STAFF REPORT

APPLICATION NUMBER RZ 81-P-116

Applicant: Board of Supervisors

Proposed Use: Single Family Attached
Residential

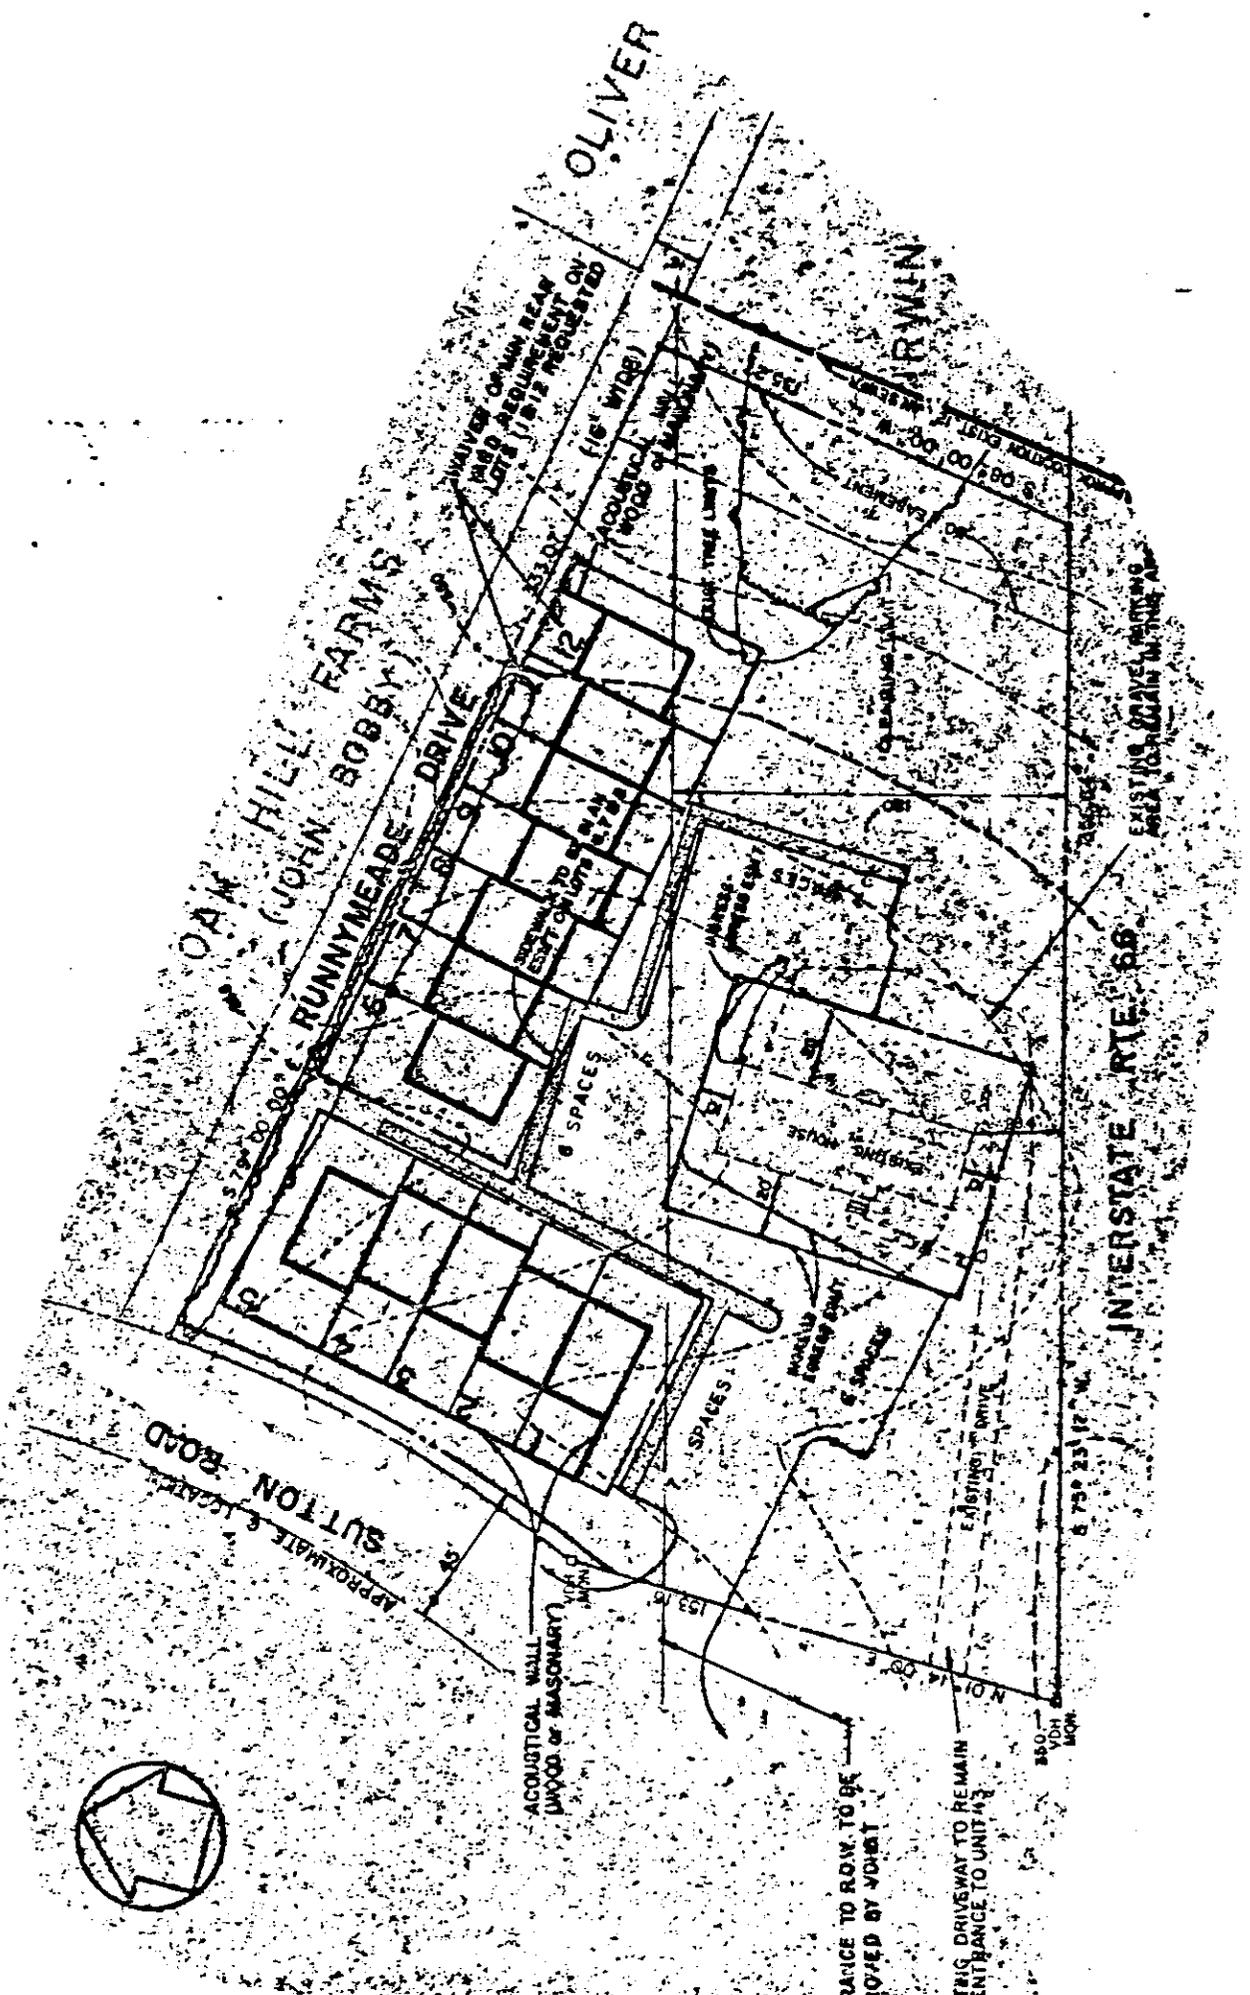
Units 11 and 12 do not satisfy either the minimum rear yard or the privacy yard requirements. Both of these requirements may be waived by the Board in conjunction with the rezoning. In addition, privacy fences are necessary for all the units.

The second factor responsible for this reevaluation was an agreement by the property owner to revise the development plan such that all proposed townhouse units (except for the southeastern corner of unit #12) would be located outside the severe (75 dBA Ldn) noise impact zone. In conjunction with this setback, the owner agreed to acoustically treat the townhouses in a manner expected to attain acceptable exterior and interior noise levels for each.

A revised and proffered development plan has situated the townhouses (except for the SE corner of #12) outside the severe noise zone. Additional proffers (Appendix 2) address the exterior and interior noise attenuation measures for the townhouses located in the 70-75 dBA Ldn zone. Staff reviewed the exterior proffer - "acoustic barriers" - and determined that it satisfies appropriate noise criteria for resolving this problem. An evaluation of the proffer for interior noise mitigation revealed that it lacked sufficient commitment to adequately mitigate the projected noise impacts on all townhouse units; including that portion of unit 12 which is located within the 75 dBA Ldn noise zone.

The development plan for this application shows two entrances, both of which are located on a curve. The geometrics of this curve limit sight distance to some extent. Although field inspection indicates that sight distance may be adequate, final determination must be made by the Department of Environmental Management and VDH&T at the time of site plan review when detailed engineering information would be available.

The major entrance to the development is also located too close to Country Creek Road to meet crossover spacing standards and the quality of access to the site would be reduced if a raised median is constructed on Sutton Road. Left turn access would then no longer be possible. Therefore, development in this area ideally should be consolidated so that access via Country Creek Road would also be available.
